PLANNING & COMMUNITY DEVELOPMENT DEPARTMENT  
Land Use Review Division

**RE: American Furniture Warehouse – Initial Review Comments**  
**File: CPC CP 07-00077-A5MN21, AR DP 21-00219, AR FP 21-00220**

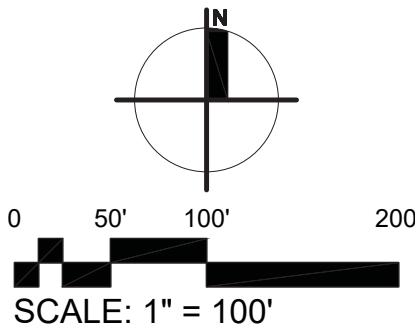
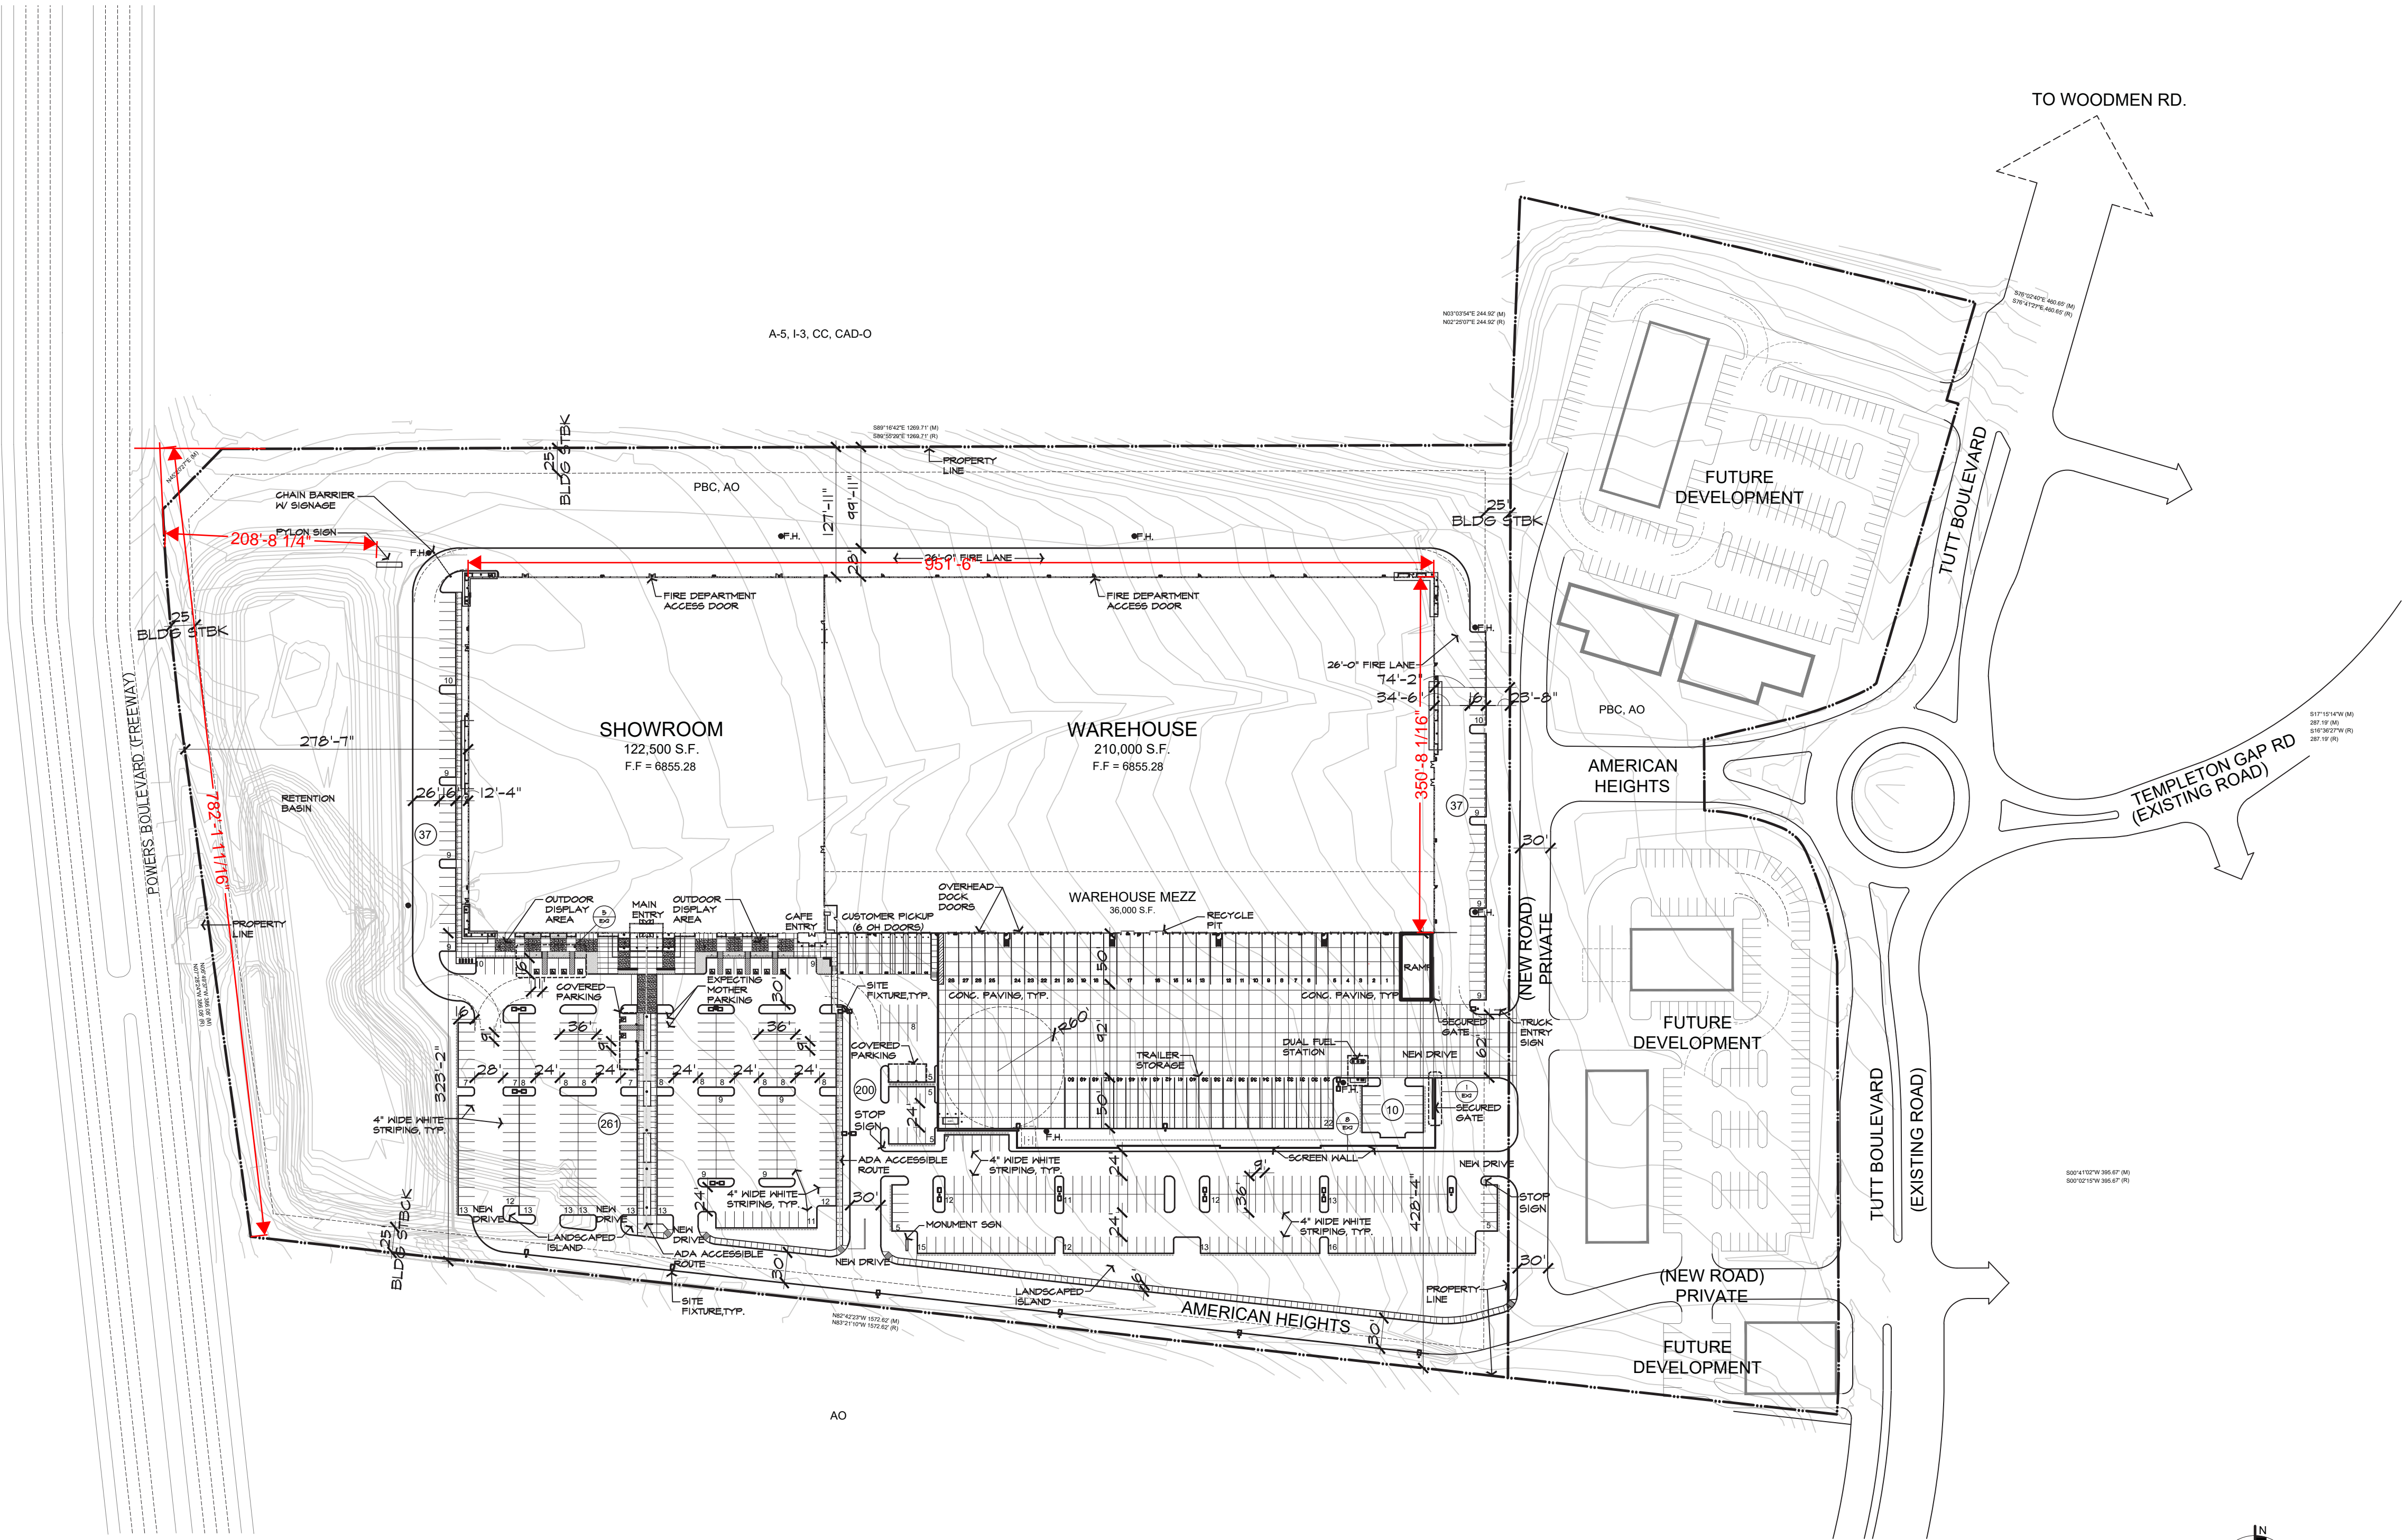
Wall signs = 2sf per linear (all walls meet 200+ linear foot setback from right of way)

North and South walls = 951'-6" = 1904sf Allocation  
East and West walls = 350'-8" = 702sf Allocation

Standard code for Ground Signs = (1) quantity determined by Western frontage  
782 linear feet = 150sf x 30ft OAH with EMC allocation up to 50% or proposed total (50% Static) - No frontage on East side so no ground signs permitted other than directional or directory signs.

EX 01

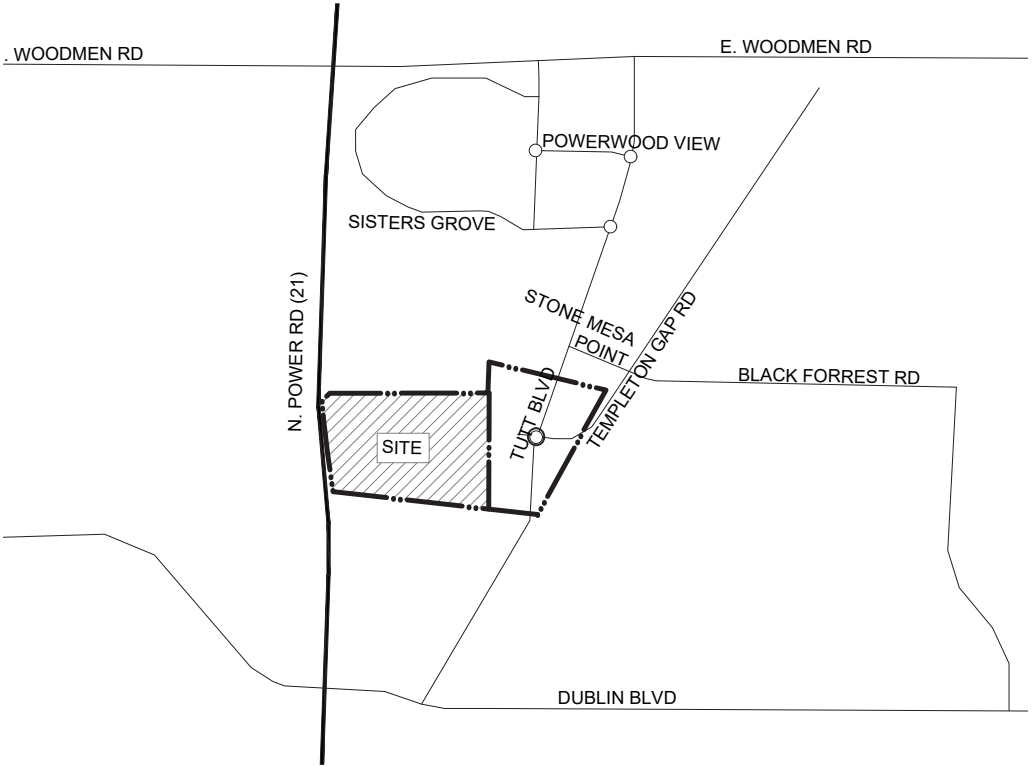
6. On Sheet EX01, there appears to be a fourth access onto Tutt shown on the southeast point of the property. From other sheets, it appears this will not be added. Please show this consistently on all sheets and pending Traffic Engineering approval, call this out as To Be Constructed.

1. On Sheet 5 (EX01) identify the objects/area in which the apparatus turning radius crosses as shown at the northeast corner of the building. Adjust the plans accordingly if needed to allow adequate apparatus turning movements.

2. Please show and callout "on sheet EX1 of the Development Plan" the speed line of sight with the adequate sight distance length (footage) for all access points along Tutt Boulevard.

## EX 10

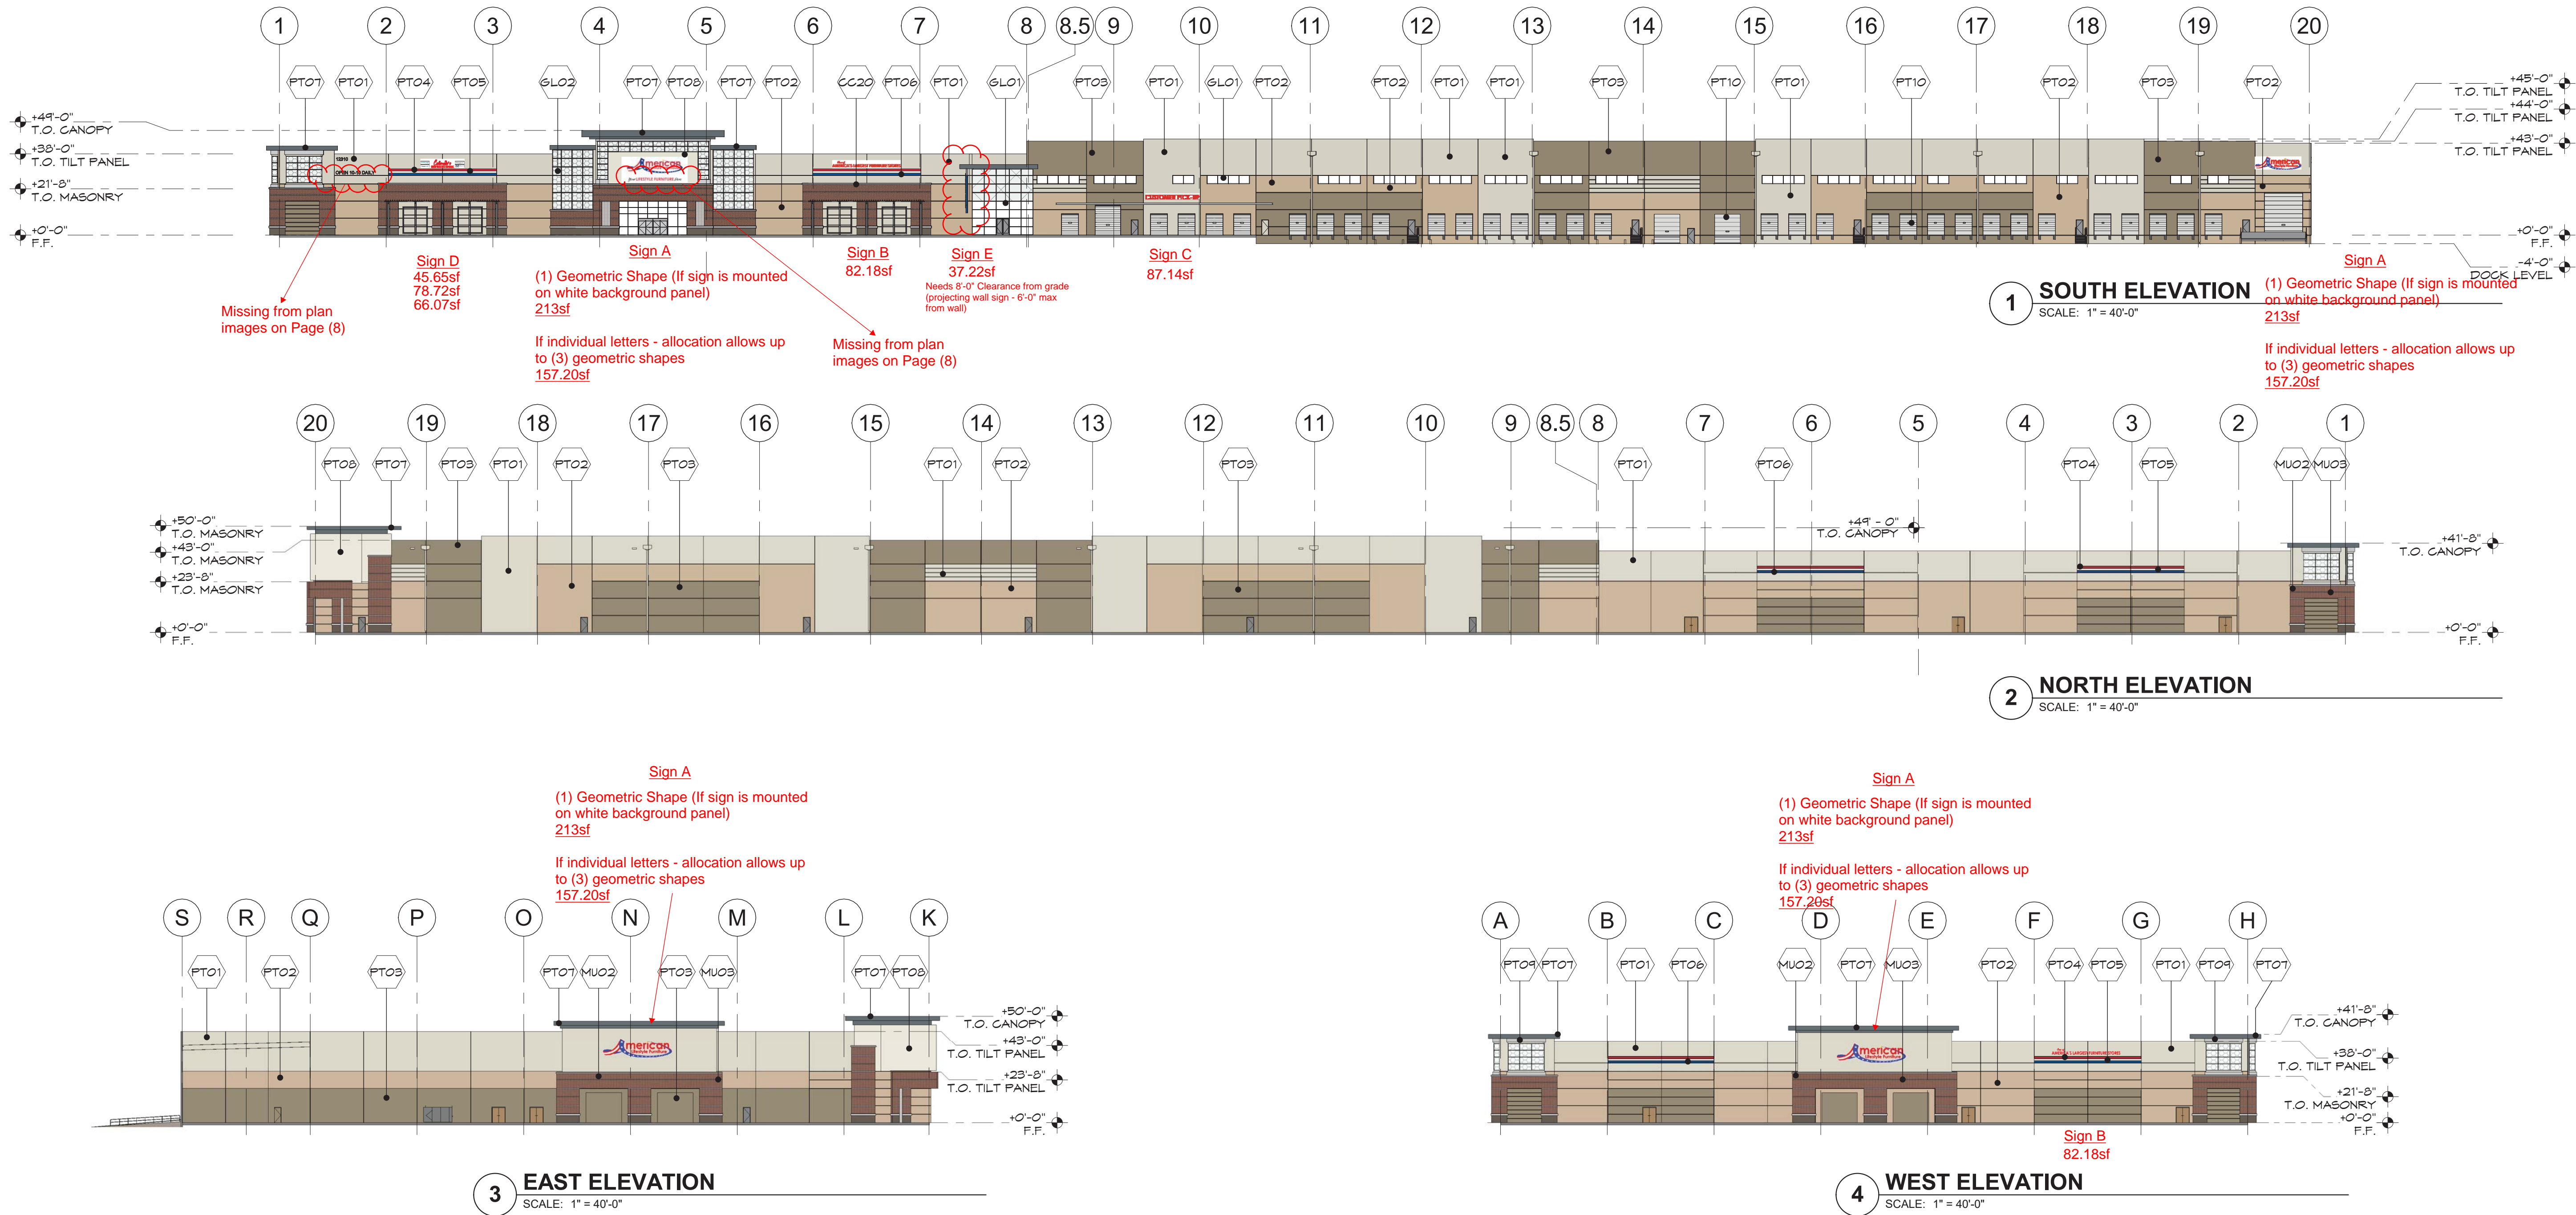
After reviewing the “Elevation” plan (page 8) and the “Plan Image” details (page 14) there is missing information required to identify total square footage proposed.

- On the East wall, there are (2) two signs identified. (1) as “Open 10-10 Daily” and (1) as “Lifestyle Furniture” that does not show dimension details. – Please provide
- In addition, the elevation drawings show the main “American Furniture Warehouse” signs with a “white” backer which would require the whole dimension of the sign panel to be calculated however on the plan image (page 14) it appears that the signage is individual lettering and may use up to (3) three geometric shapes to provide allocation. (see attached document for reference)
